STAFF REPORT

APPLICATION RZ/FDP 2009-PR-021

PROPOSAL: The applicant seeks to rezone 6.15 acres from R-1 to PDH-3 to permit 16 single-family detached residences at a density of 2.60 du/ac.

Title of Plan: Amanda Place

CONCEPTUAL LANDSCAPE PLAN

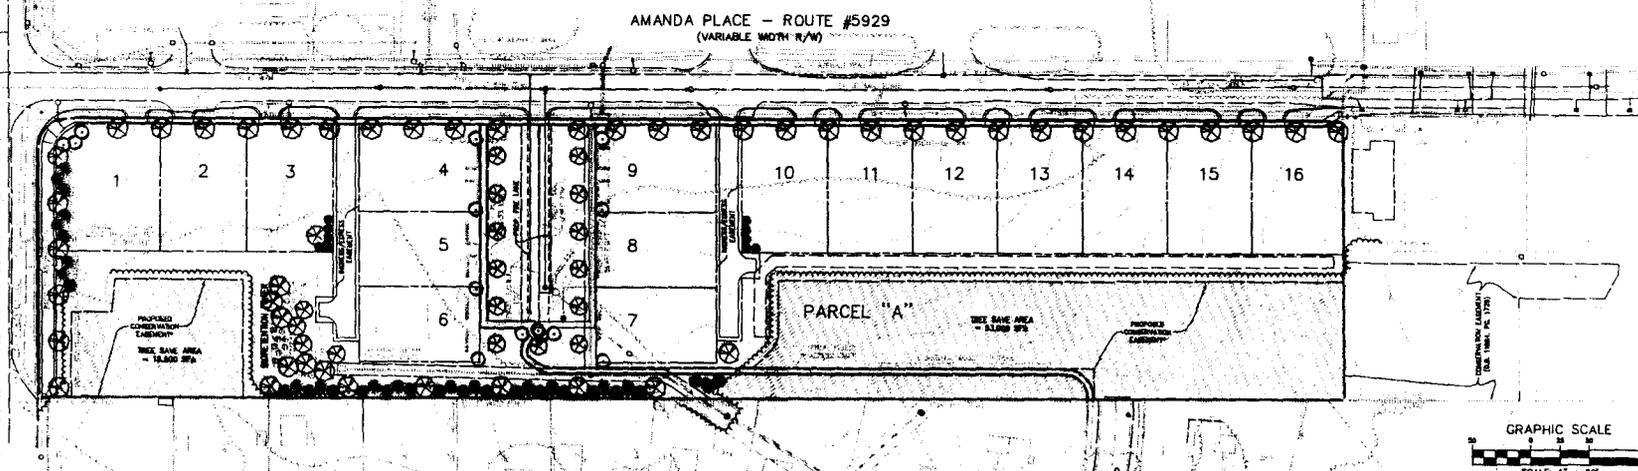
Staff also asked the applicant for more specific detail about the proposed new landscaping plantings for this site as a whole and on individual lots.

In addition, the applicant has provided specific details on the placement and types of plantings on the typical lots and has proffered to submit a landscape plan during the site plan review in substantial conformance with the CDP/FDP which will be subject to review by Urban Forest Management (UFM). Therefore, this issue is resolved.

25. Landscaping. At the time of site plan review, the Applicant shall submit to DPWES, a landscape plan showing landscaping consistent with the quality, quantity and general location shown on the Landscape Plan on Sheet 4 of the CDP/FDP. This plan shall be subject to review and approval of Urban Forestry Management, DPWES. At the time of planting, the minimum caliper for deciduous trees shall be two and one-half (2.5) inches to three (3) inches and the minimum height for evergreen trees shall be seven (7) feet. Actual types and species of vegetation shall be determined pursuant to more detailed landscape plans approved by Urban Forest Management at the time of site plan approval.

SHEET 6 OF 8

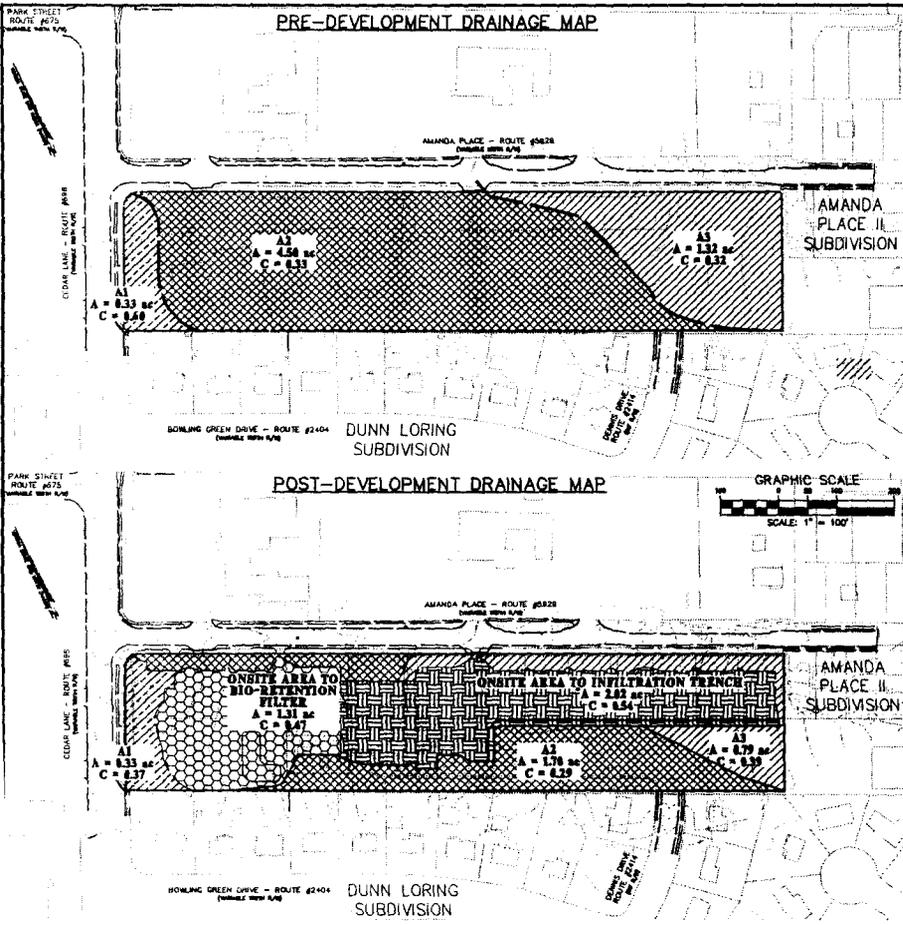
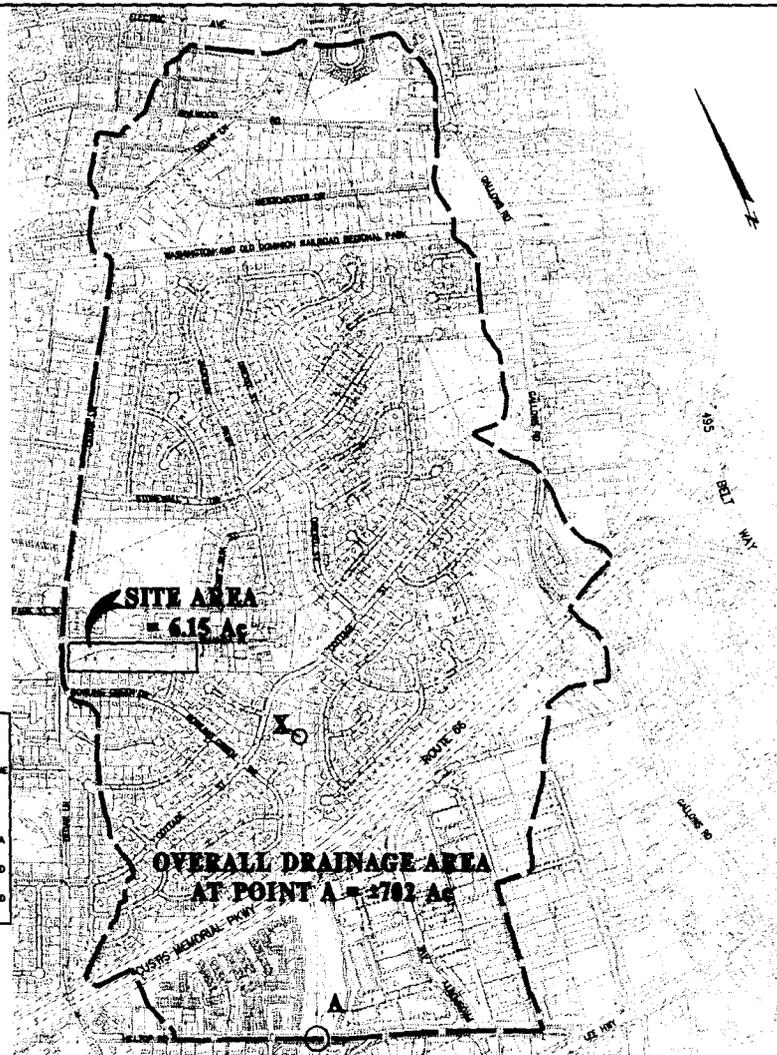
The provided outfall narrative states that the drainage pattern for the site flows in three different directions. The first area flows into a curb inlet along Cedar Lane located in the southwest portion of the property. The second area sheet flows into an existing storm sewer system through a dry pond in the center of the site.

The third area sheet flows in an easterly direction into a yard inlet located in the Amanda Place II subdivision which ultimately discharges into an existing offsite stormwater dry pond. Staff has expressed concern over the effect of the removal of the existing on-site dry pond on the stormwater management in the area. There was a previous drainage complaint at 2613 Bowling Green Drive and staff has asked the applicant to research how their development and stormwater management plan would address those drainage concerns.

The infiltration trench and bio-retention filter appear to be appropriately located to satisfy water quality and quantity requirements for this project. In response to staff direction, the applicant has recently provided more detailed calculations, post-development drainage maps and hydraulic grade line computations to depict the treatment of stormwater on this site. Staff is currently reviewing the detailed information and notes that the applicant will be expected to meet the specifications provided on Sheets 6 and 7 of the CDP/FDP and will be required to provide all relevant calculations and supporting data for review and approval during review of the site and subdivision plans.
